Project	Proposed Solar Farm and BESS – Land off Main Road, Kelham, Nottinghamshire	Document No	153626-005-03
Subject	Technical Note – Response to Consultation Responses from Nottinghamshire County Council Highways and National Highways

Overview

Nottinghamshire County Council Highways Consultation Response 31/10/2023

DRAWN S.T	DATE 21/11/2023	APPROVED C.N	DATE 21/11/2023
SCALE 1:250	SHEET A1L	DRAWING NUMBER HC1002/05/29	REVISION 0

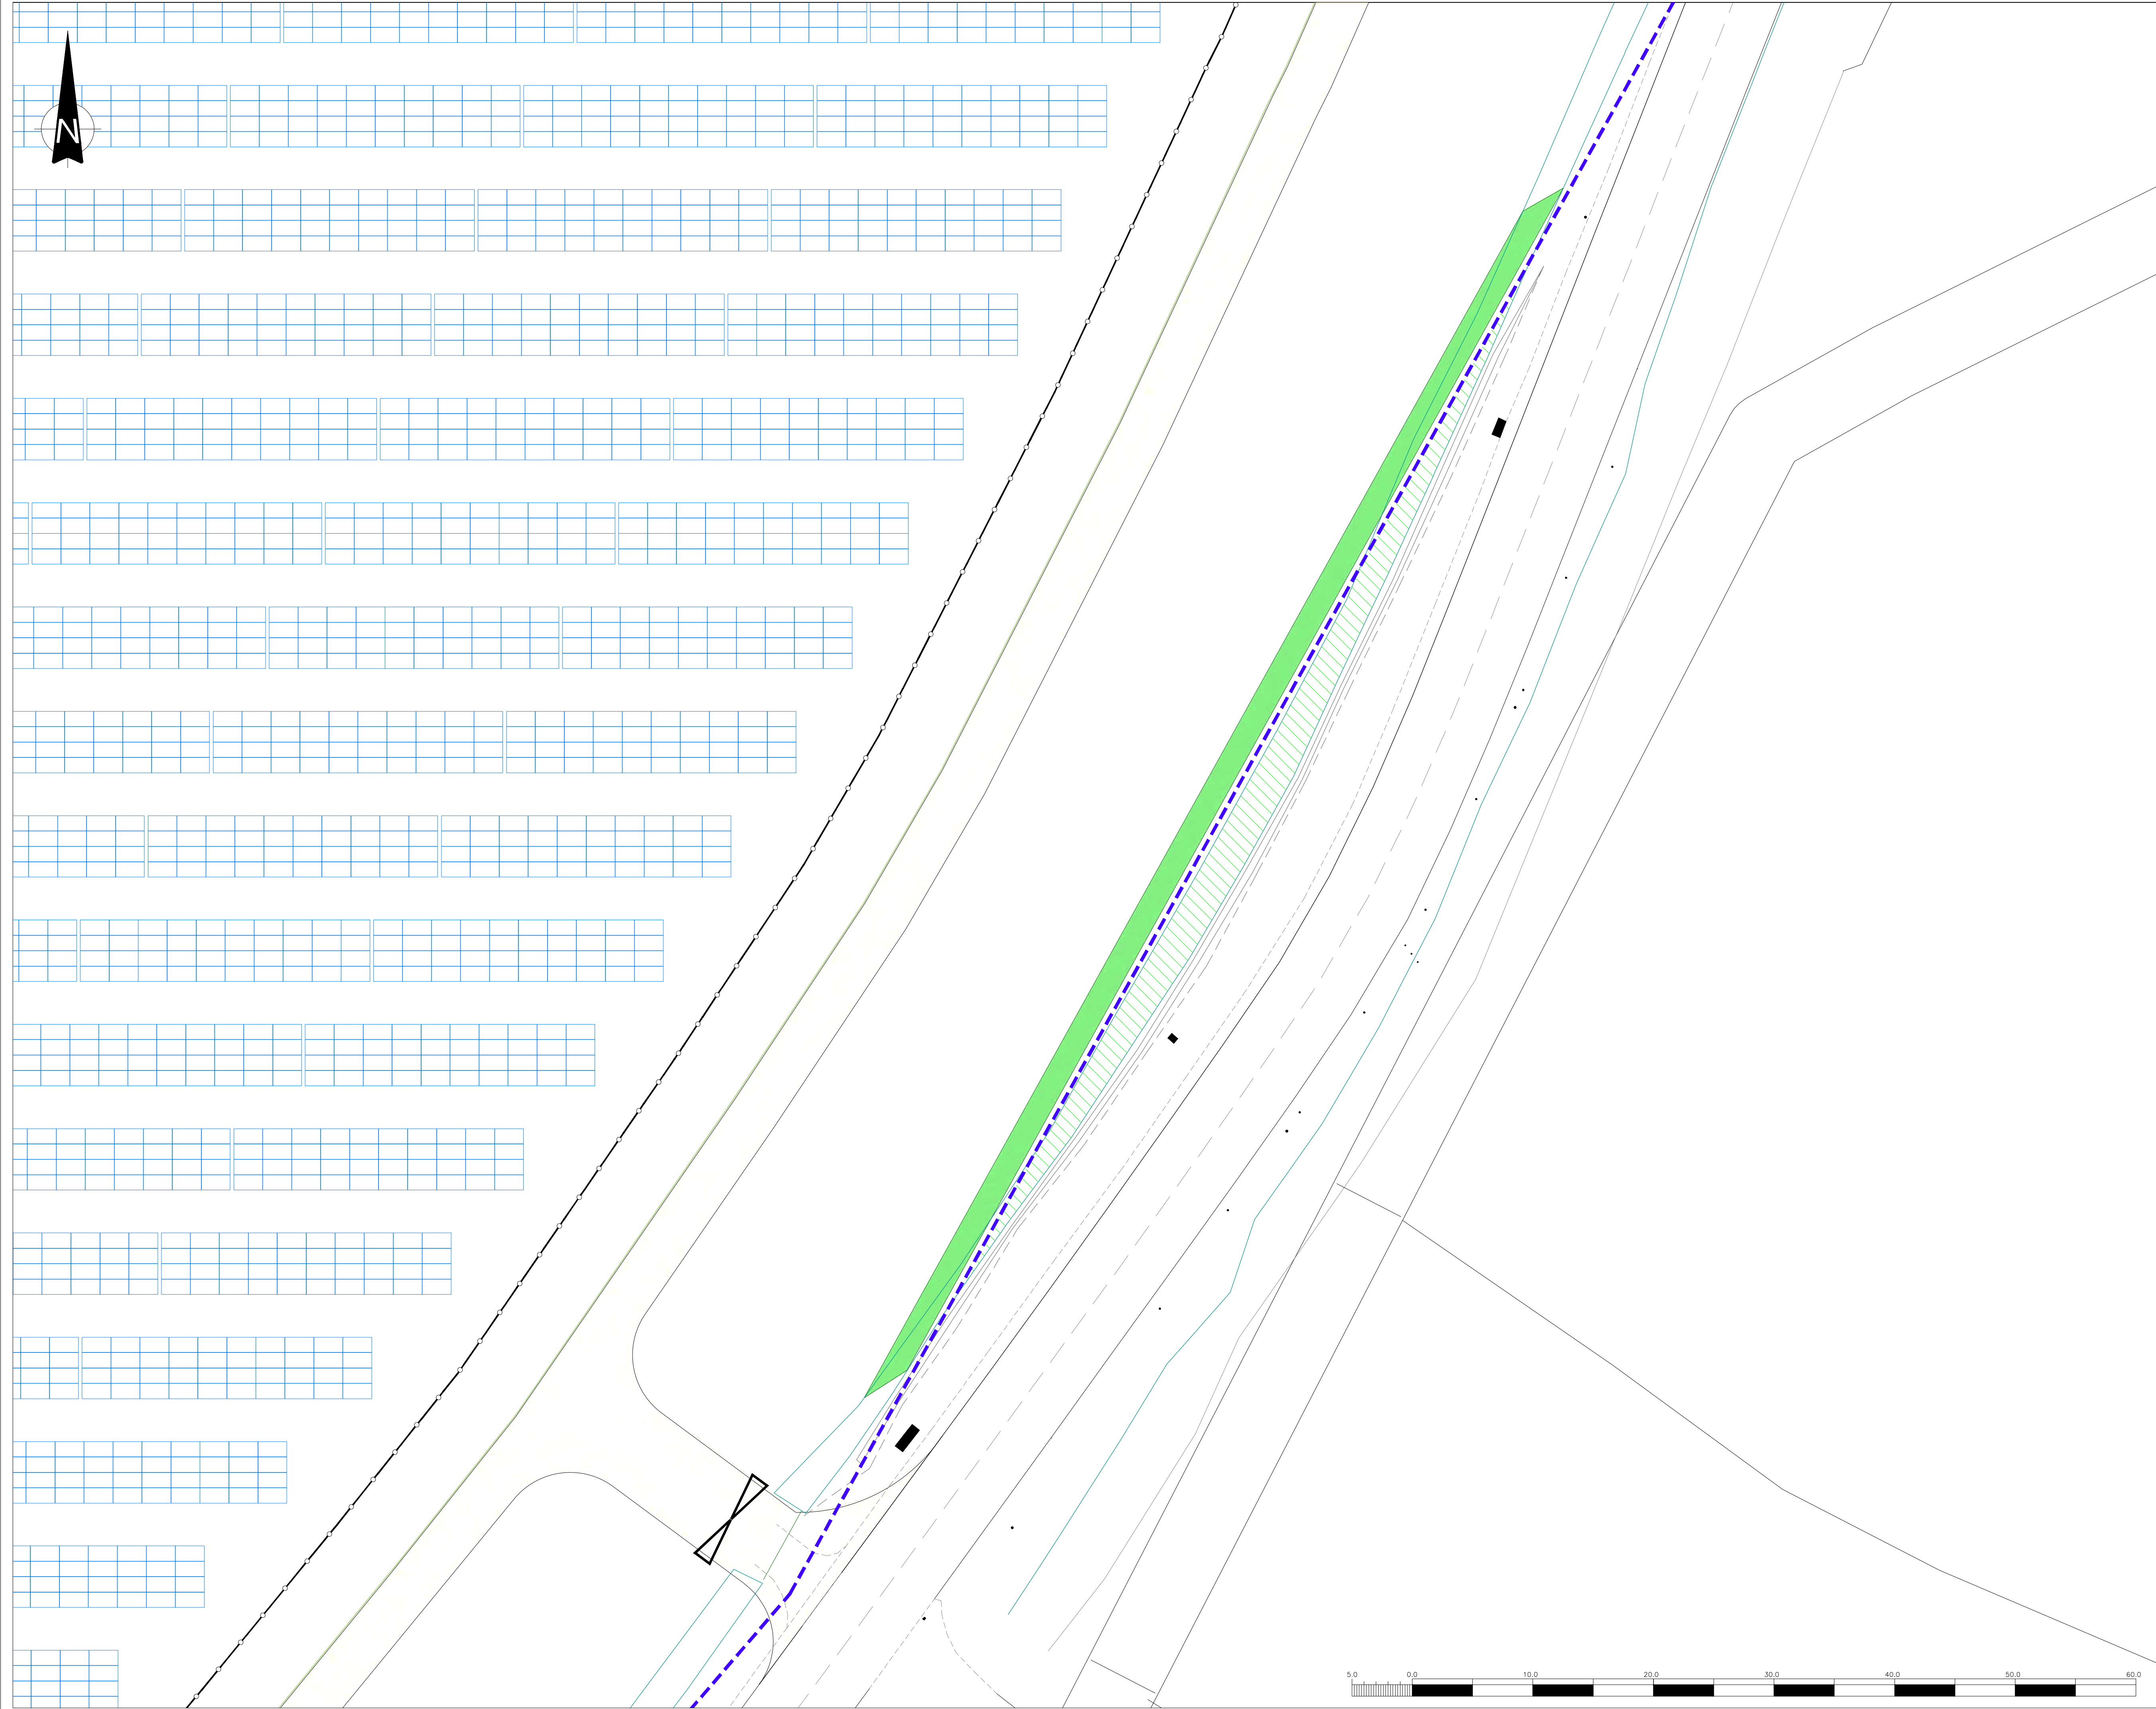
The applicant considers that retention of the existing hedgerow along the A617 site frontage is necessary, in relation to its perceived role in mitigating the landscape impact of the proposed development, and proposes that the hedgerow should not be removed to facilitate visibility splays. This results in a site access scheme that cannot meet the necessary visibility splay standards within the existing 50mph speed limit on the A617.

The applicant's landscape appraisal notes that the existing hedgerow along the eastern site frontage to the A617 is gappy. It has limited effect in mitigating the landscape impact of the proposed development. The landscape assessment and masterplan both refer to hedgerow planting alongside the internal site access road, which runs parallel to the A617. The assessment confirms that such planting would mitigate the visual impact of the proposed development by substantially screening low level views into the site from the A617. This would offset impacts associated with the necessary hedgerow removal along the A617 to provide an access that meets visibility splay standards.

It is proposed that the existing hedgerow along the site frontage to the A617 will be translocated, as shown on Drawing HC1002/05/29 R0 included at Appendix E, to provide unrestricted visibility for emerging vehicles.
